## ORIGINATION FORM

### Proposed Revisions to a Standard Plans Index

Index Number: 509-070

Index Title: Railroad Grade Crossing Traffic Control Devices

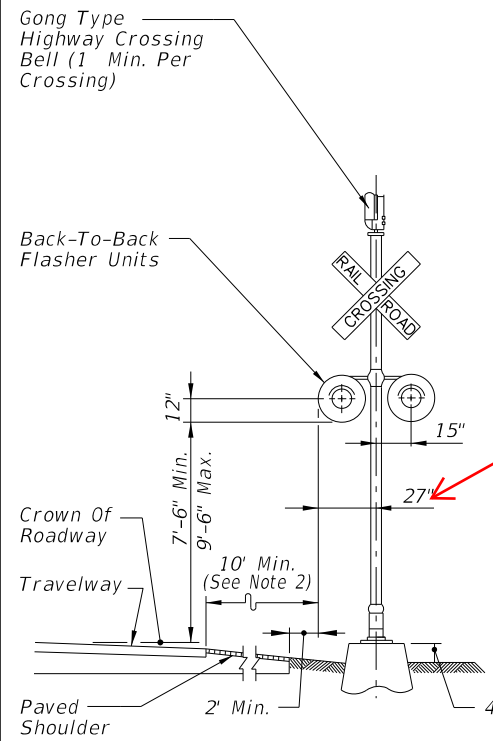
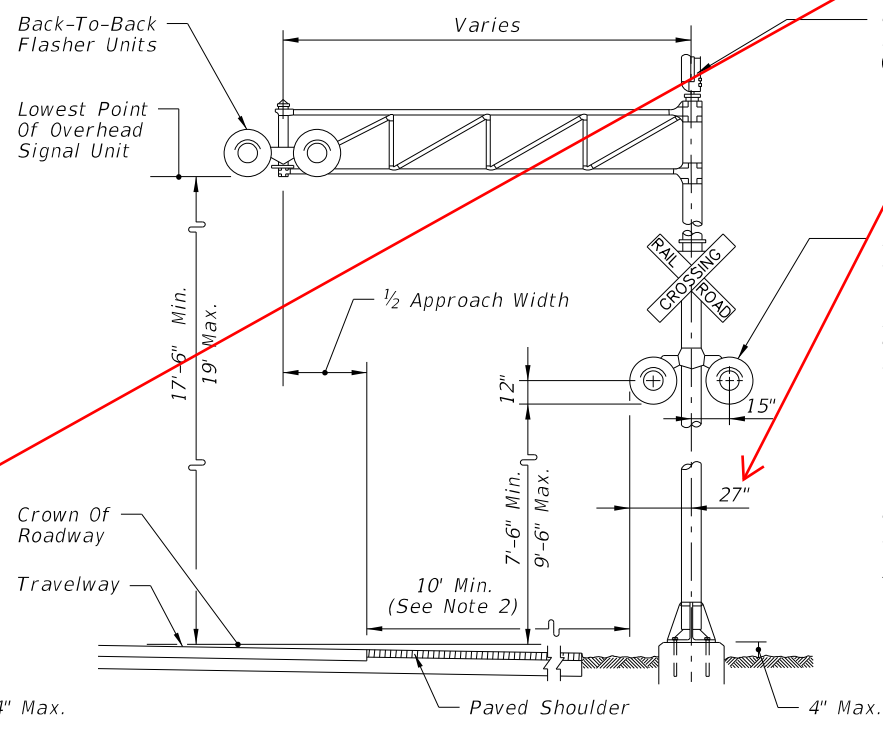
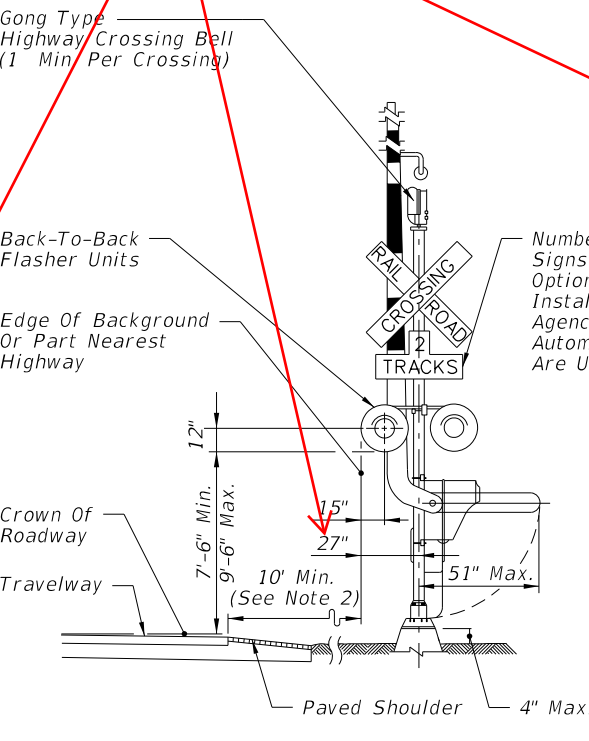
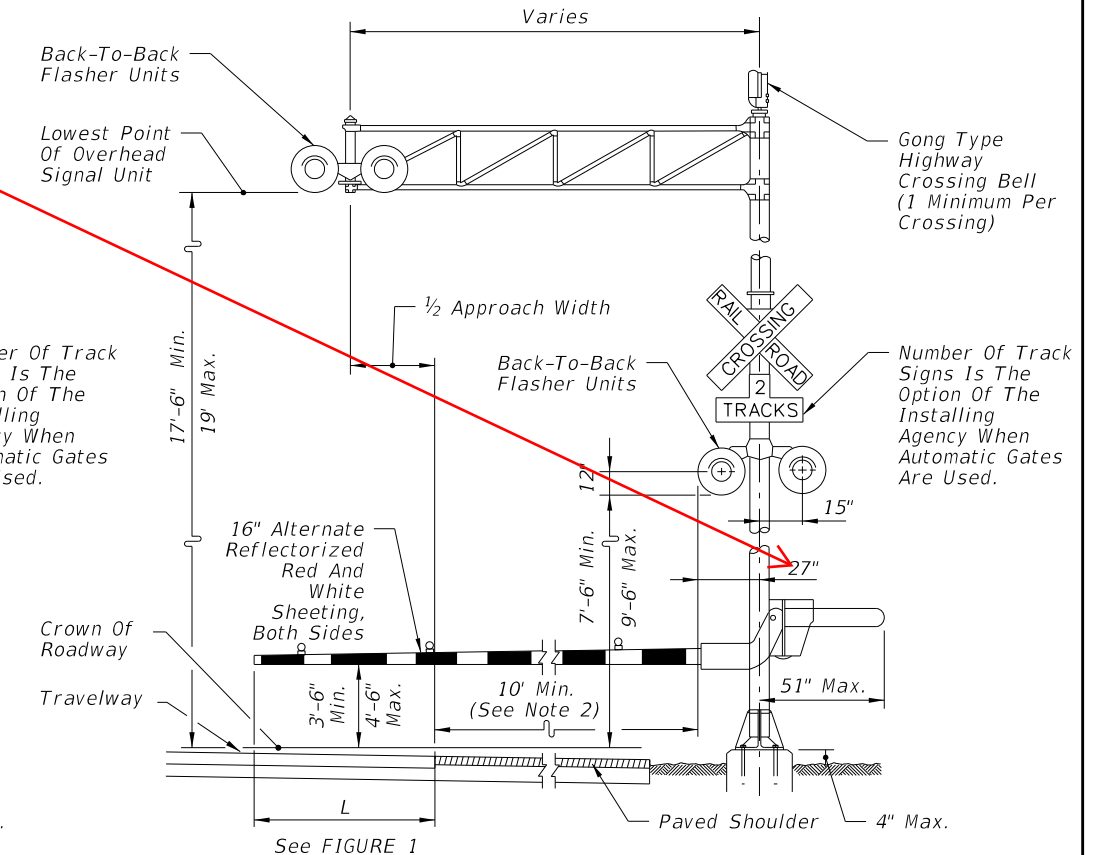
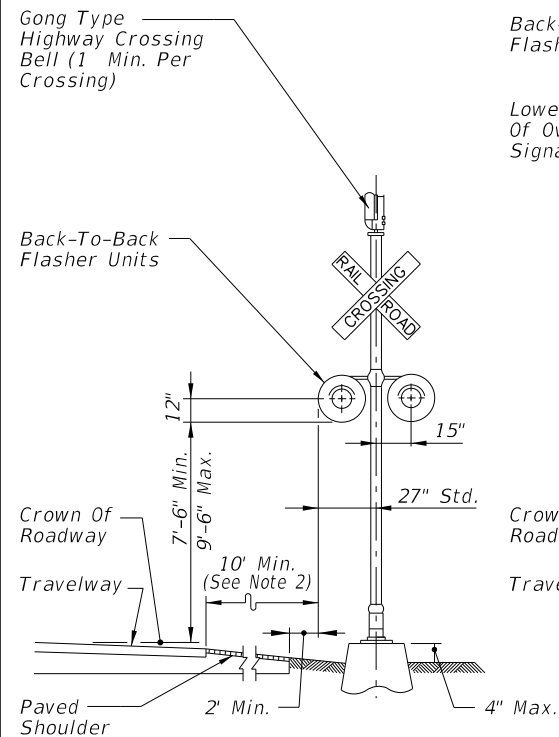
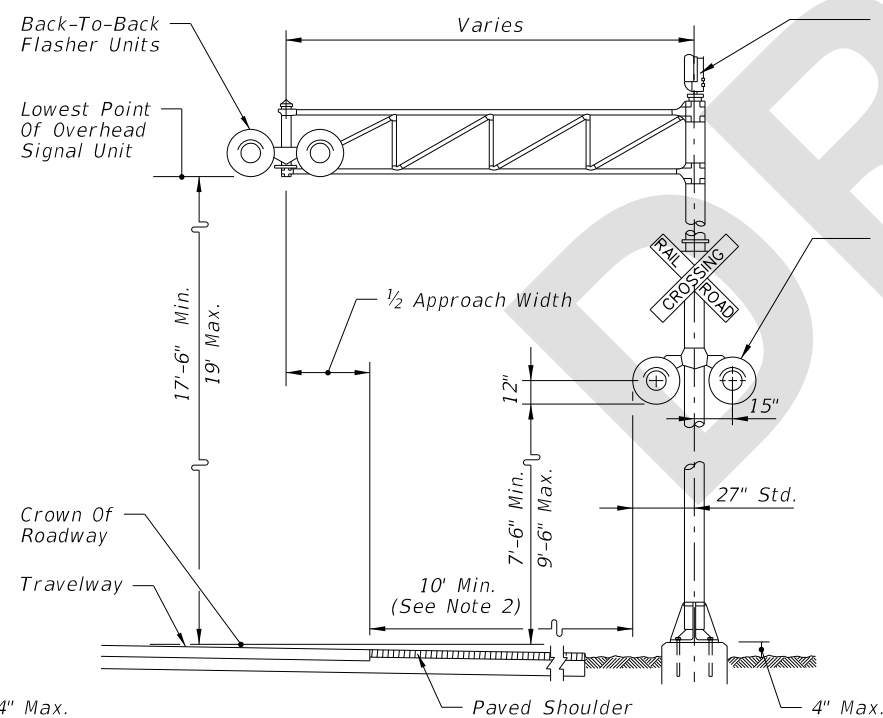
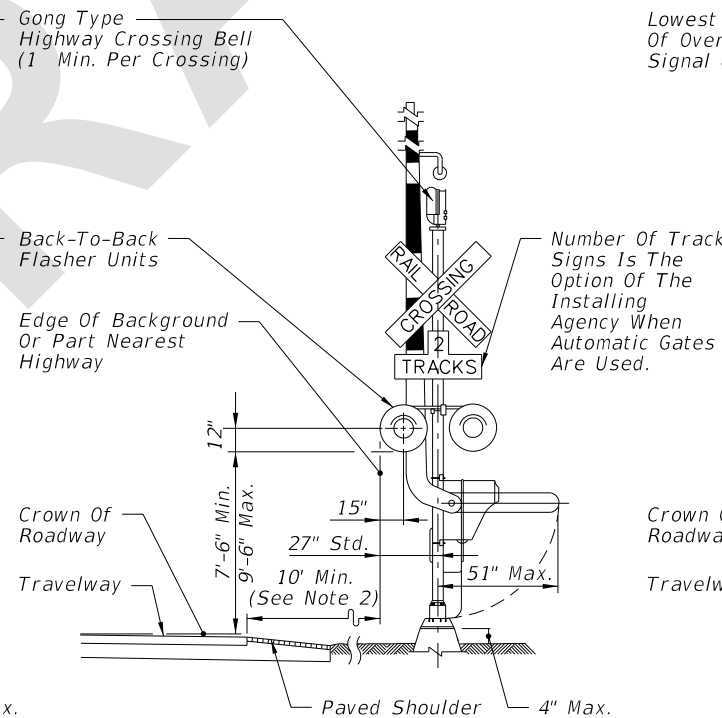
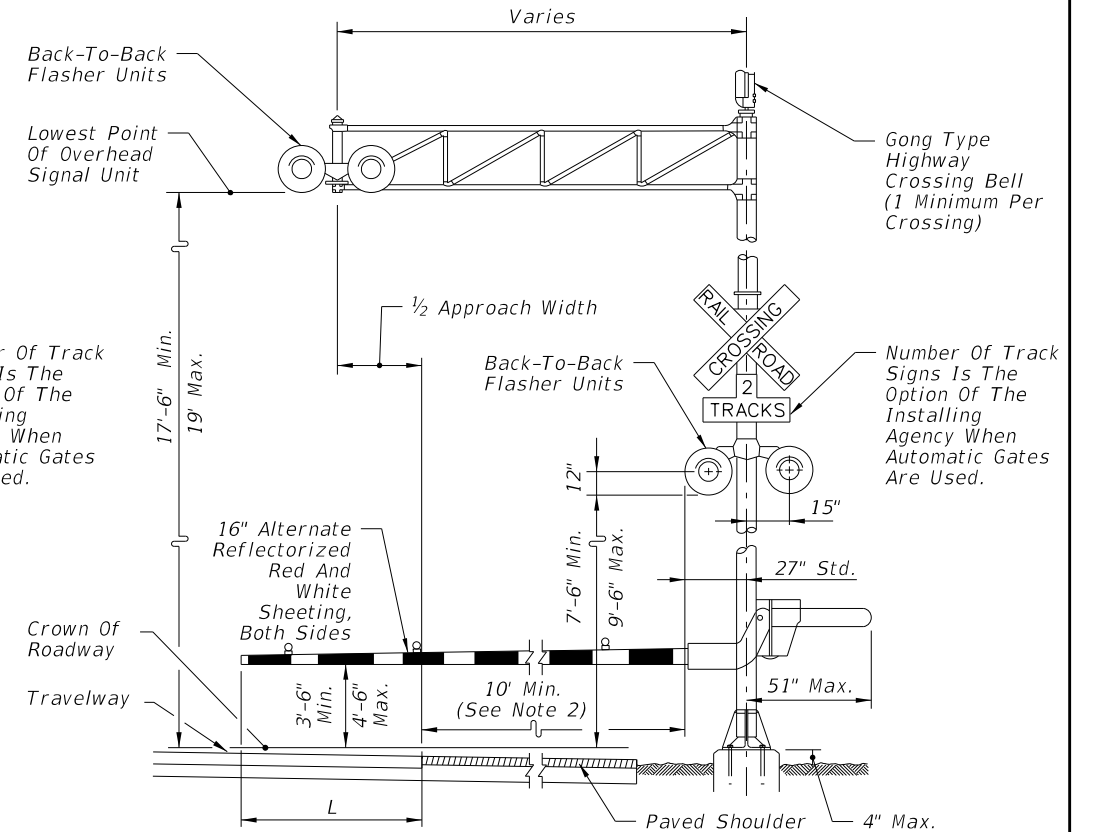
Sheet 1: Change General Note 5 , Class VI to 3-4; Delete Type V and Type VI from Traffic Control Devices for Flush Shoulder Roadway Details: Added "Std." to the 27" dimension in Type I through Type V.

CHANGED TO: 3-4

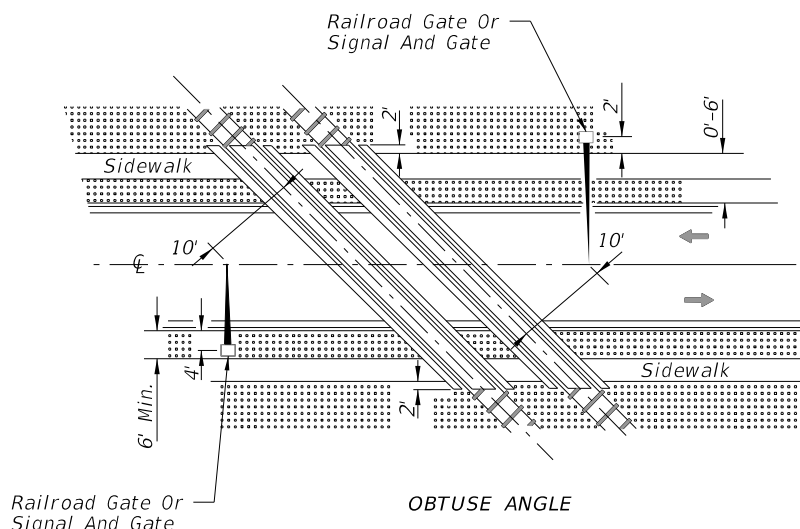
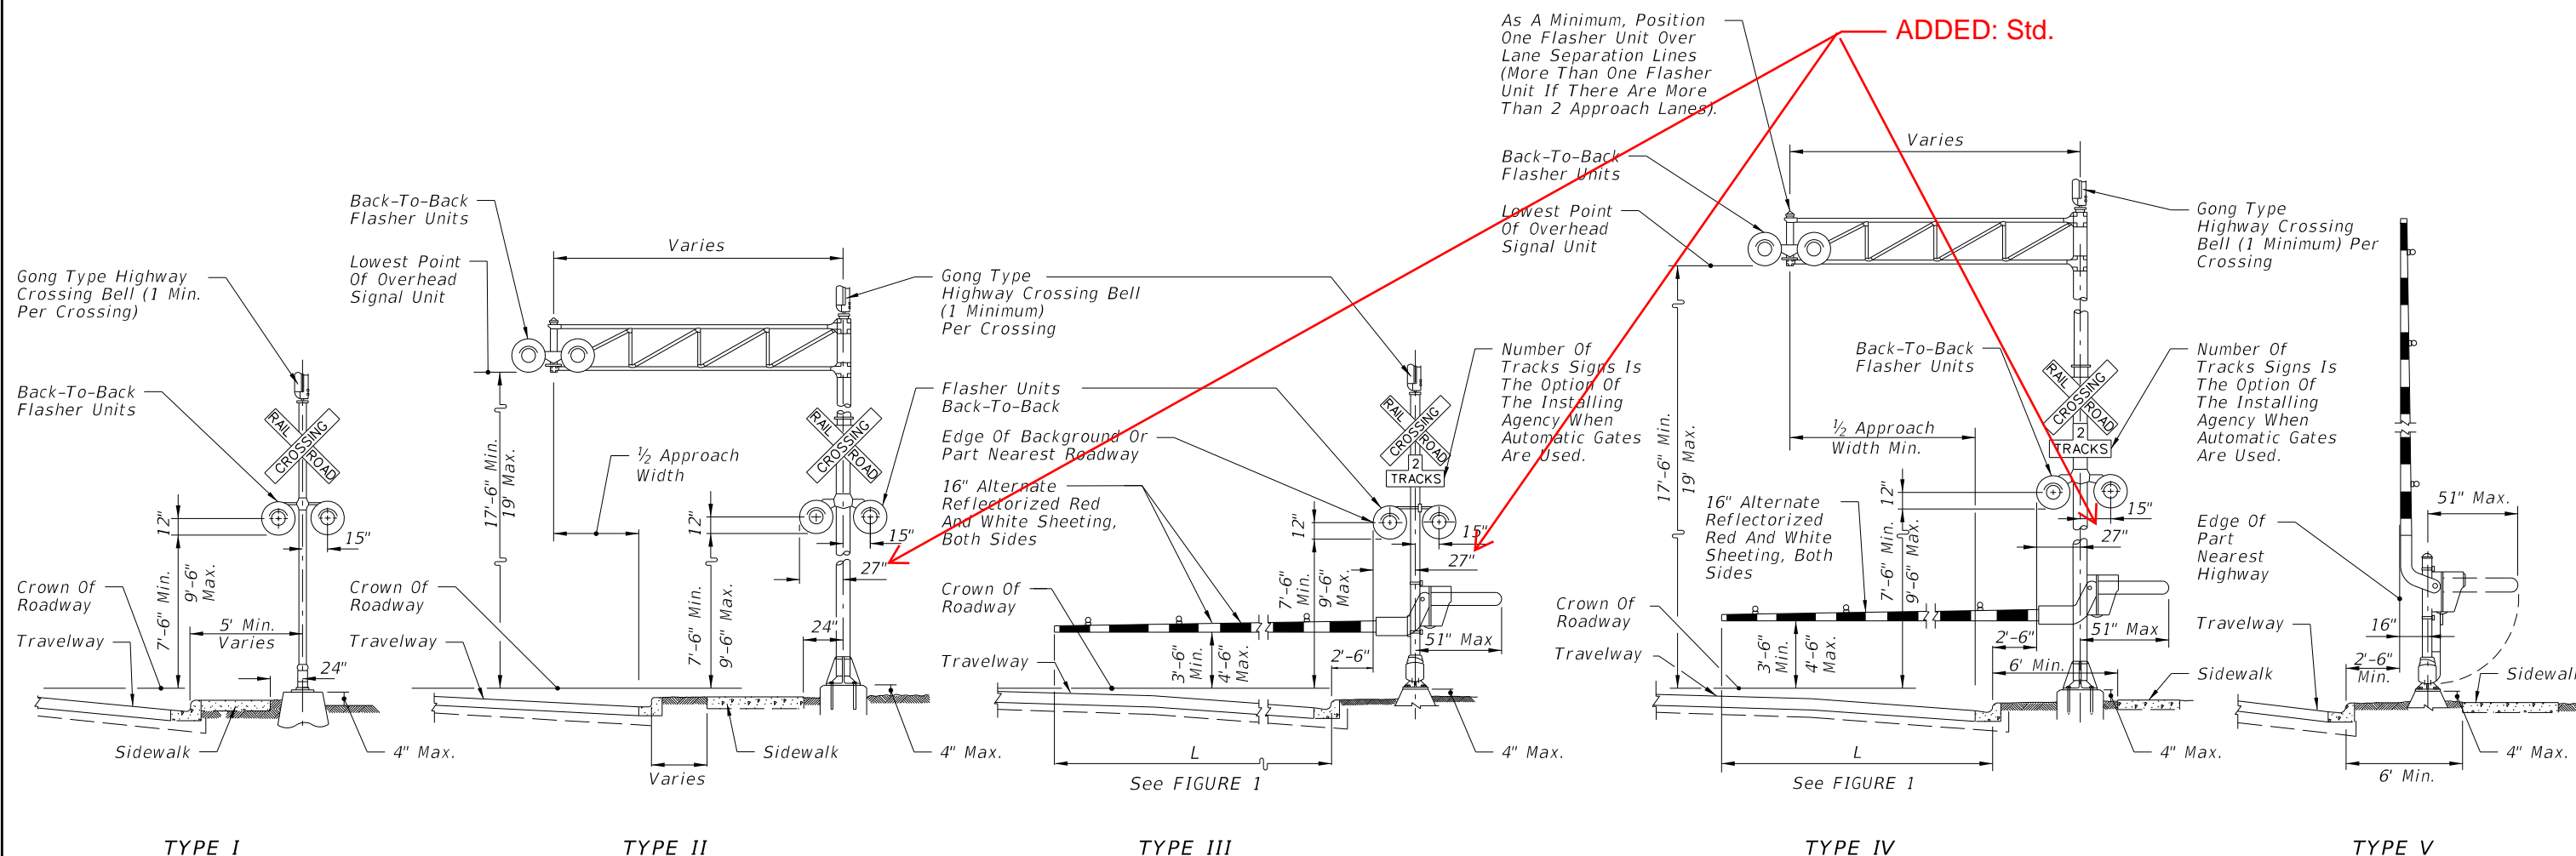
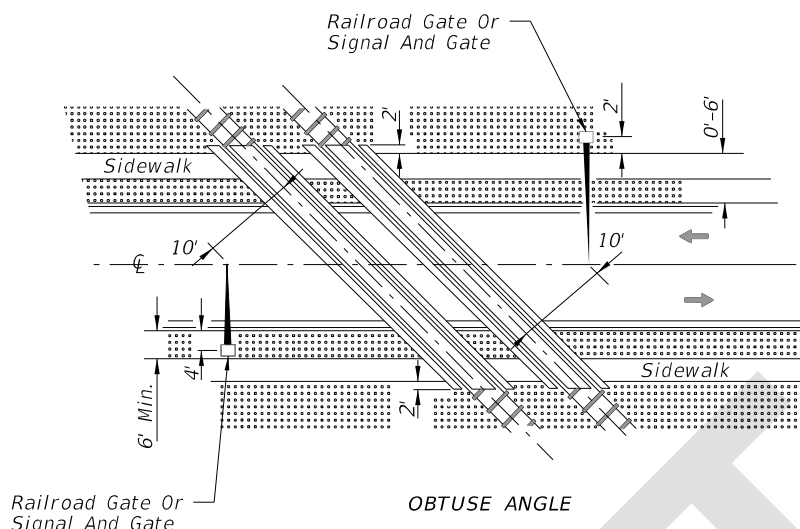
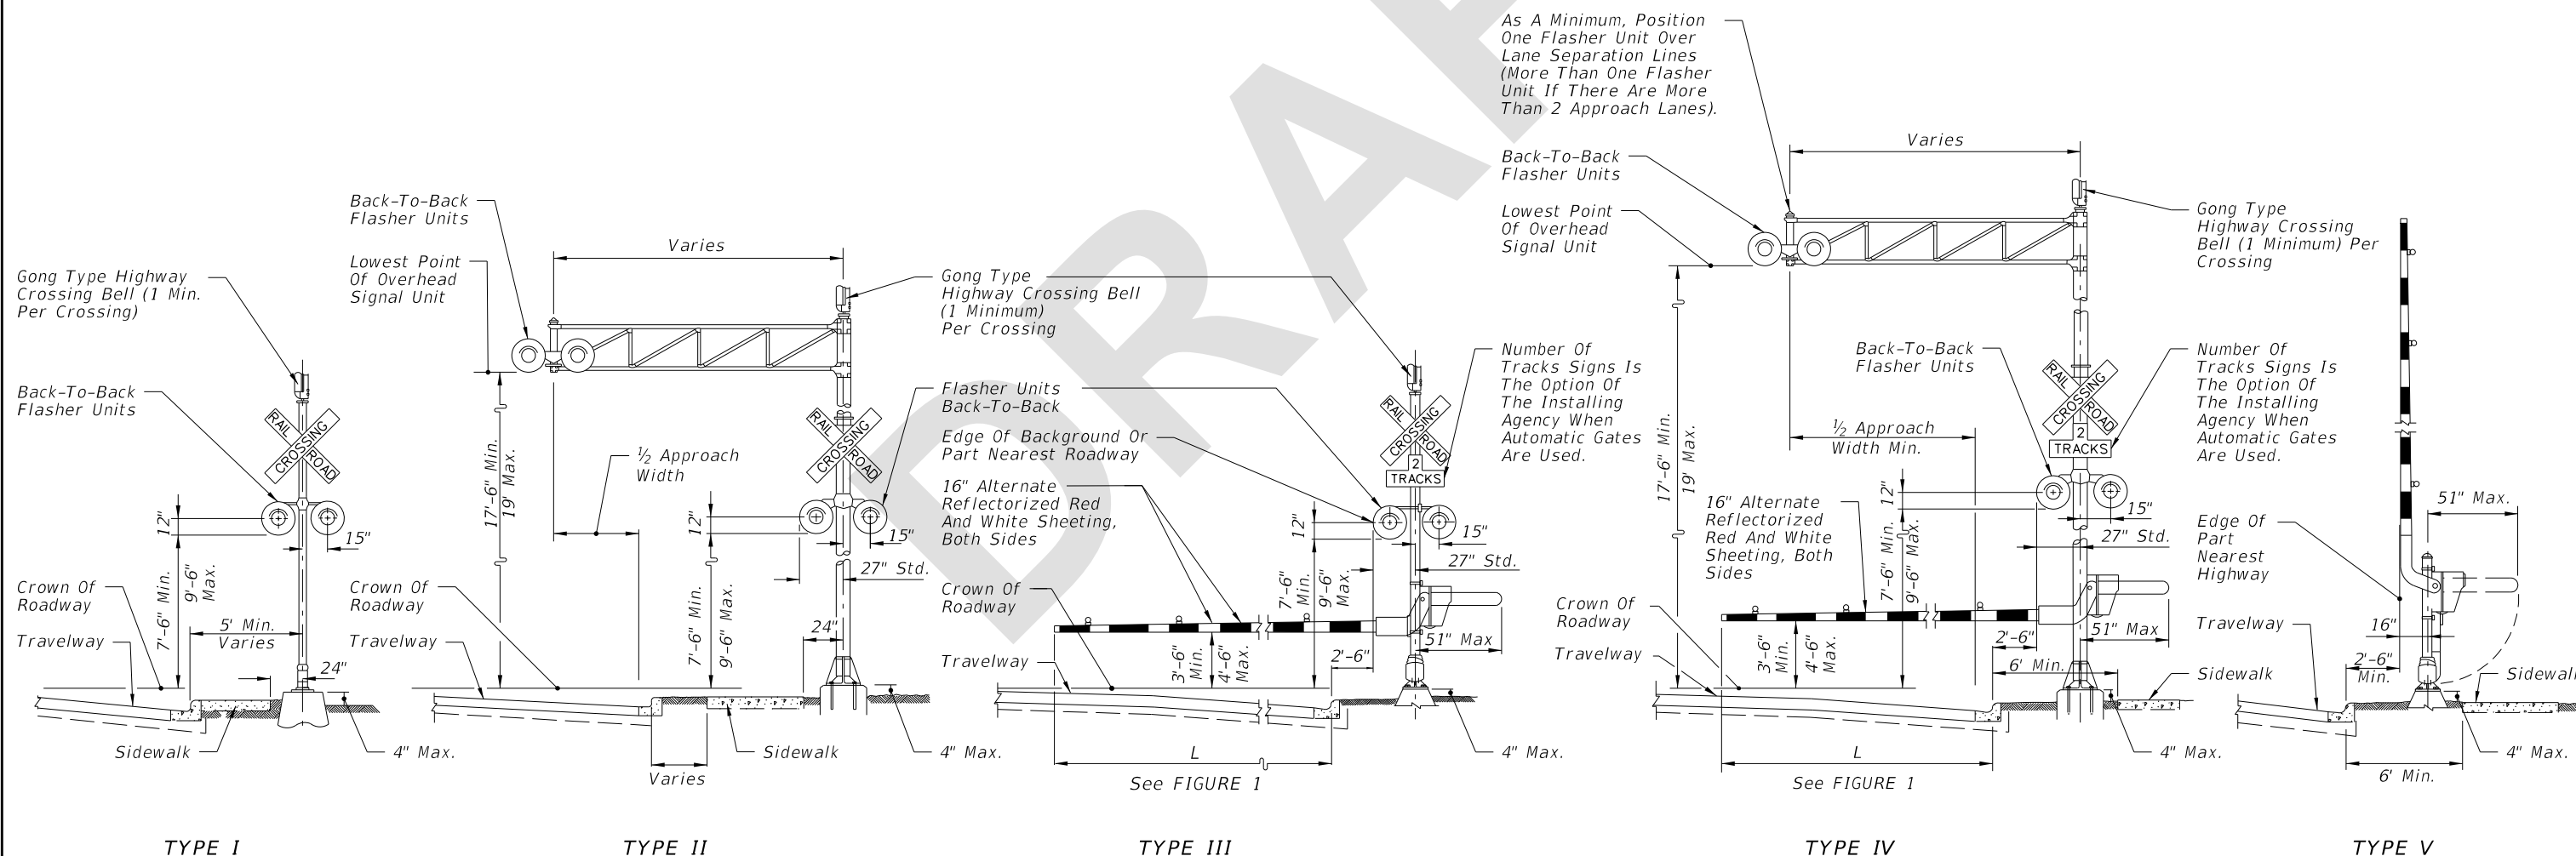
Sheet 2: Added "Std." to the 27" dimension in Type II through Type IV.

PLAN

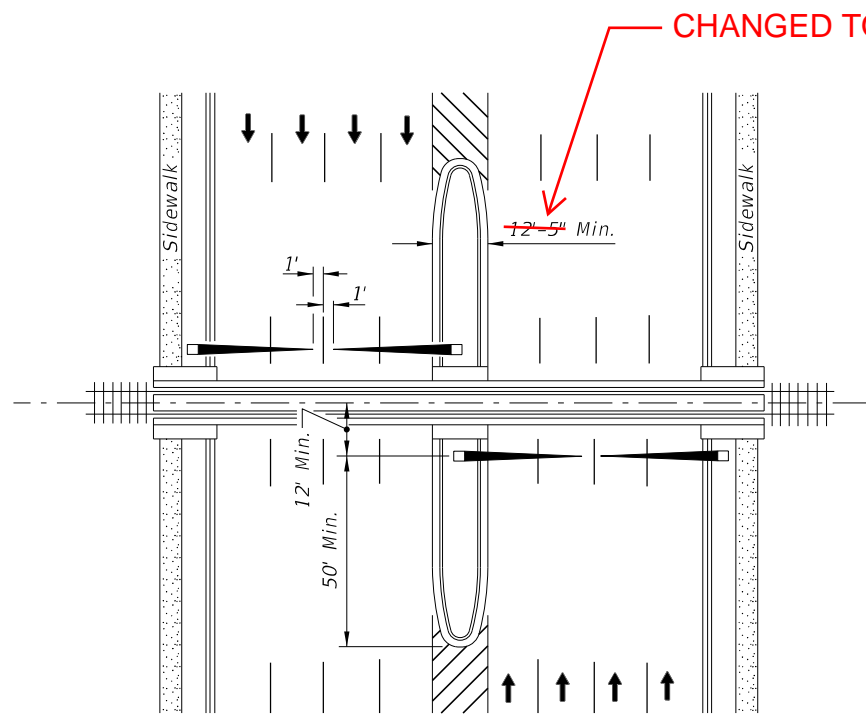
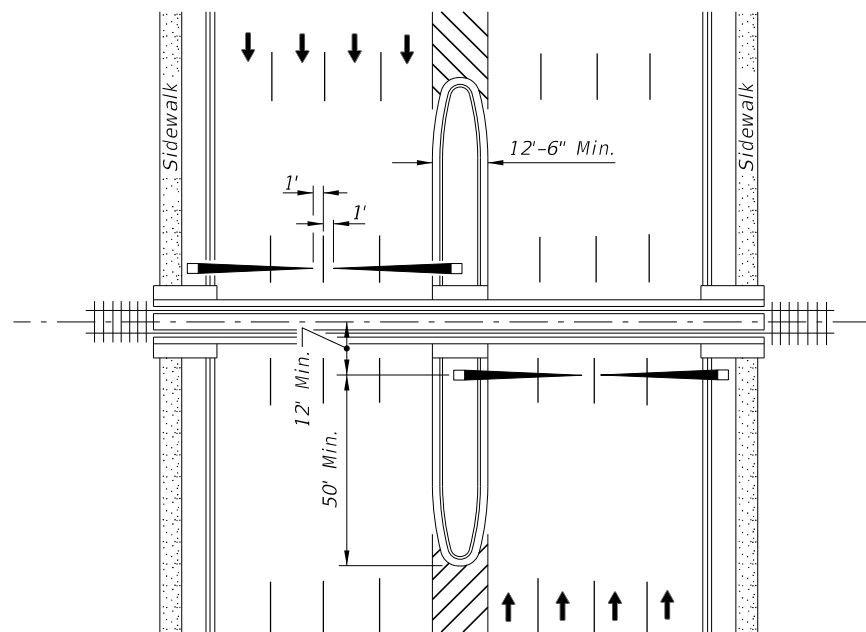
Sheet 3: Change 12'-5" min to 12'-6" Min. in PLAN; Change 51" Max to 57" Min in Median Section at Signal Gates Detail.
